STRUCTURAL ADDENDUM No. 01

Project No: ALL-21013718

Project: PEC LTC

Project Title
 Owner
 PRINCE EDWARD COUNTY- LONG TERM CARE REDEVELOPMENT
 Sheet Title
 SECTION

7 SECTION

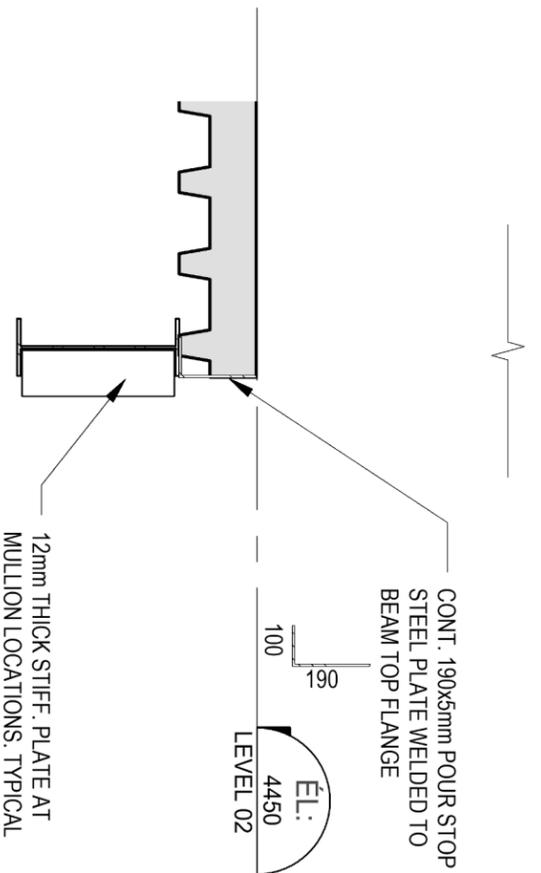
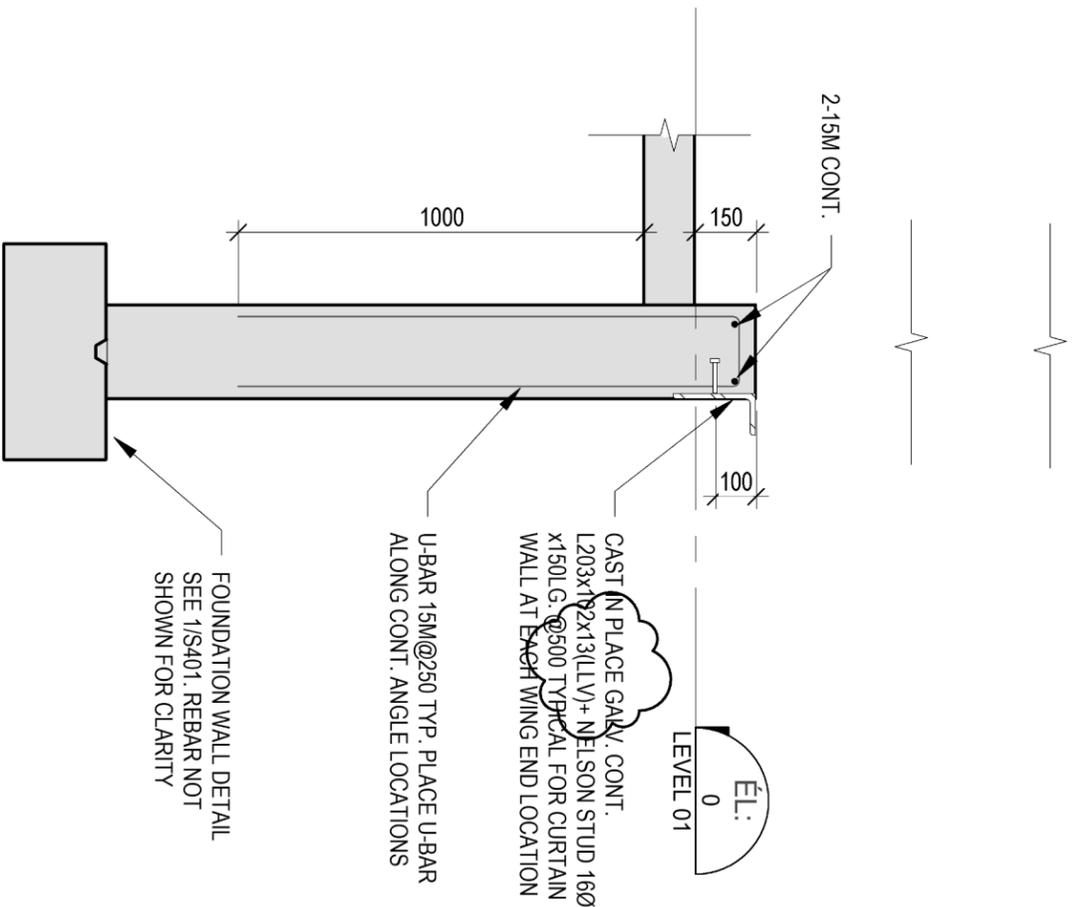
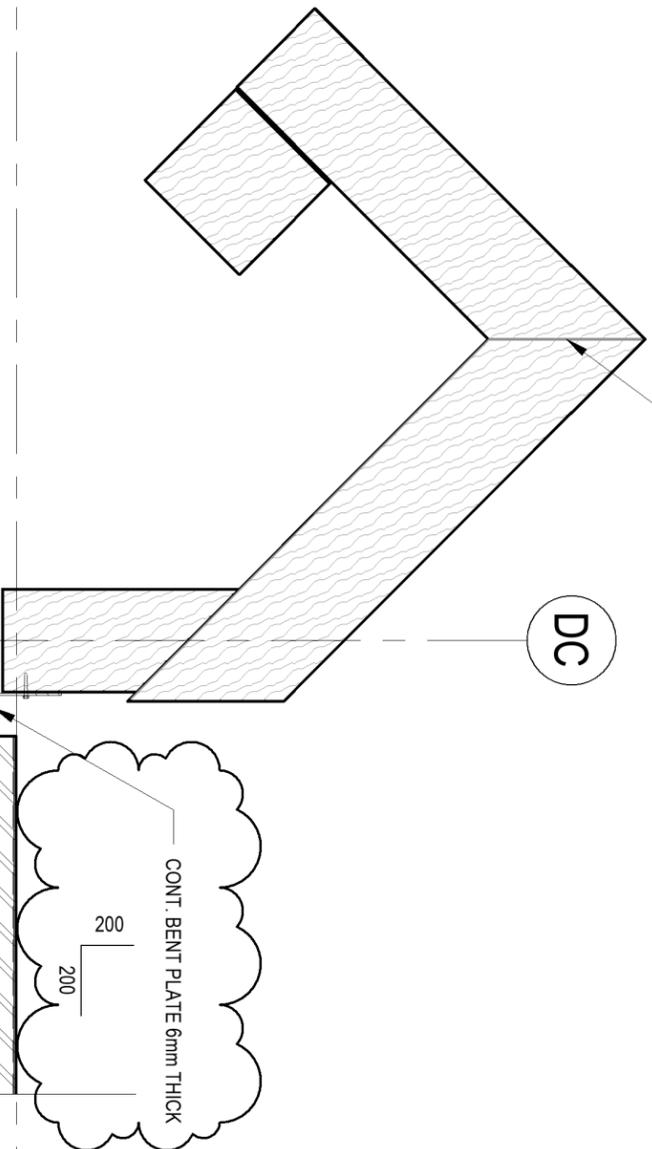
1.3. SK-S103

- Section 7/S401 has been updated.

HSS 152x152x6.4 WIND GIRT FOR CURTAIN. TYPICAL AT EACH WING END LOCATION. CONNECT GIRT TO STEEL COLUMN OR CONCRETE WALL WITH EP01

CONT. 190x5mm POUR STOP STEEL PLATE WELDED TO BEAM TOP FLANGE

12mm THICK STIFF. PLATE AT MULLION LOCATIONS. TYPICAL

CAST IN PLACE GALLY. CONT. L203x192x13(LLV)+ NELSON STUD 16Ø X150L.G. @500 TYPICAL FOR CURTAIN WALL AT EACH WING END LOCATION

U-BAR 15M@250 TYP. PLACE U-BAR ALONG CONT. ANGLE LOCATIONS

10 SECTION

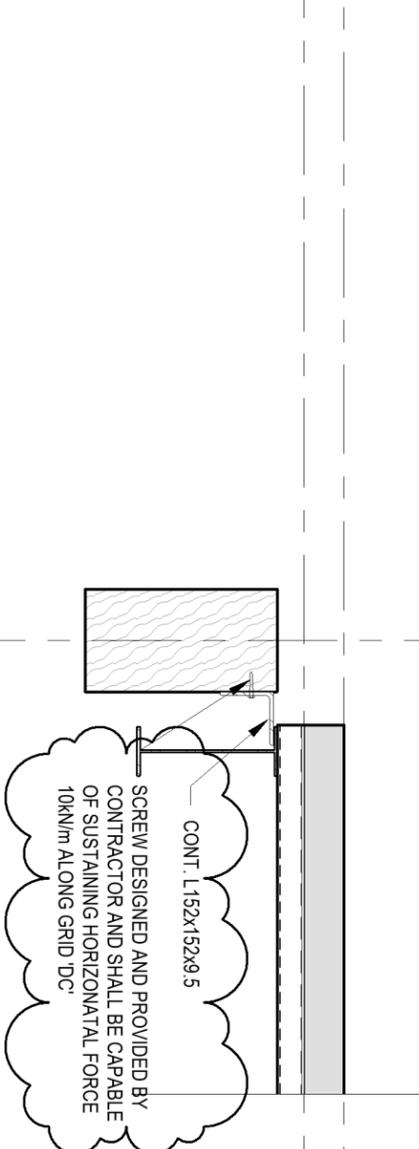
1.4. SK-S104

- Section 10/S402 has been updated.
